**MFN 14-071, Supplement 1, Revision 1**

**GEH Response and Revised Supplemental Response  
to RAI 01.05-1**

**ABWR DCD DRAFT Revision 6 Markups**

## 2.6.2 Fuel Pool Cooling and Cleanup System

Figure 2.6.2 Fuel Pool Cooling and Cleanup System

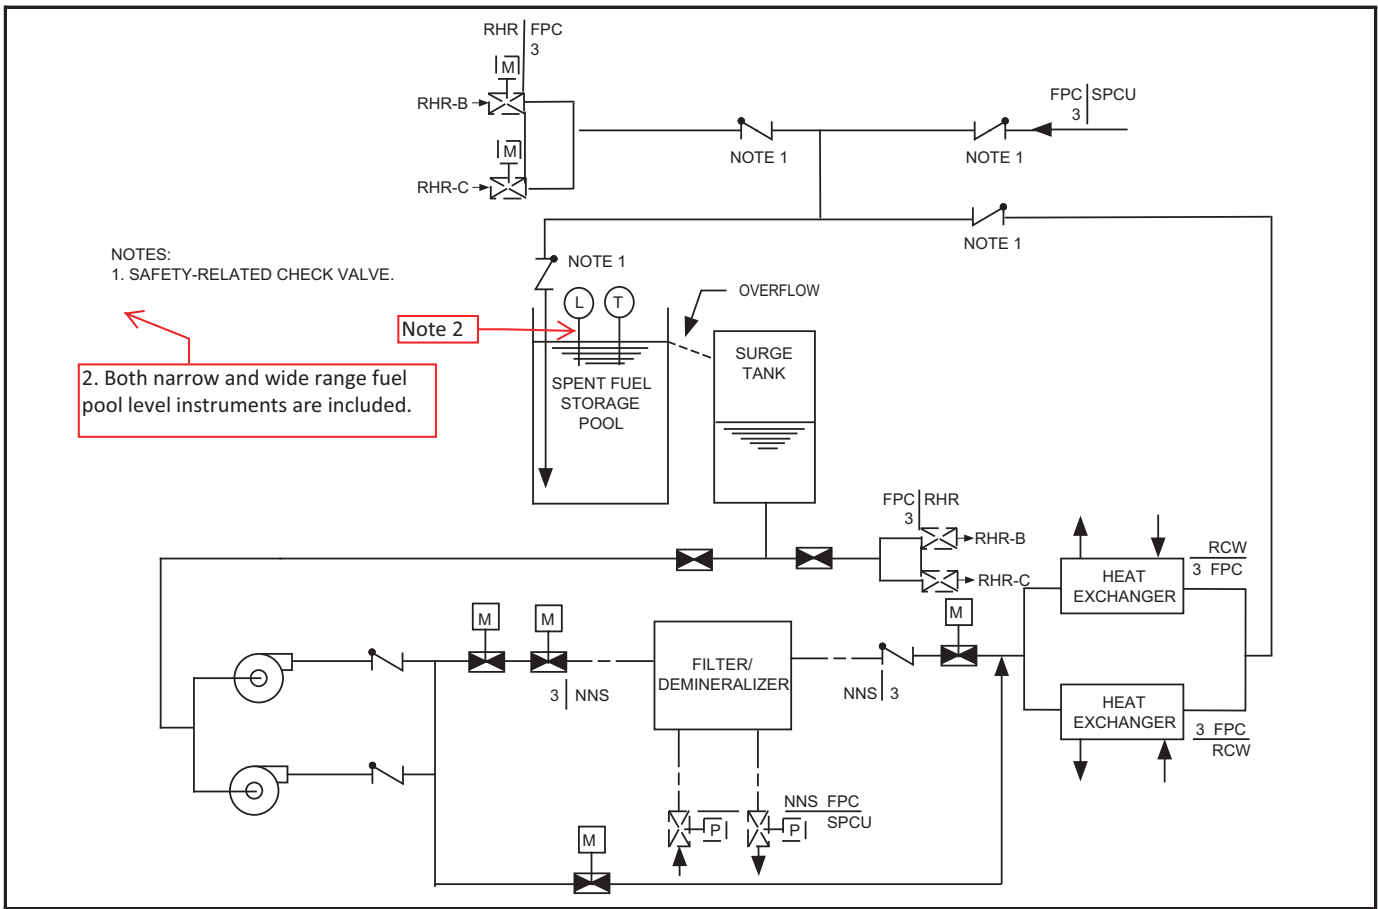
(for example, narrow range water level)

The FPC System has non-safety parameter displays in the main control room for instruments shown on Figure 2.6.2. In addition, two safety-related spent fuel pool wide range level instruments are provided. Indication of the spent fuel pool level is provided in the Main Control Room (MCR) as well as in another appropriate area that is accessible post-accident.
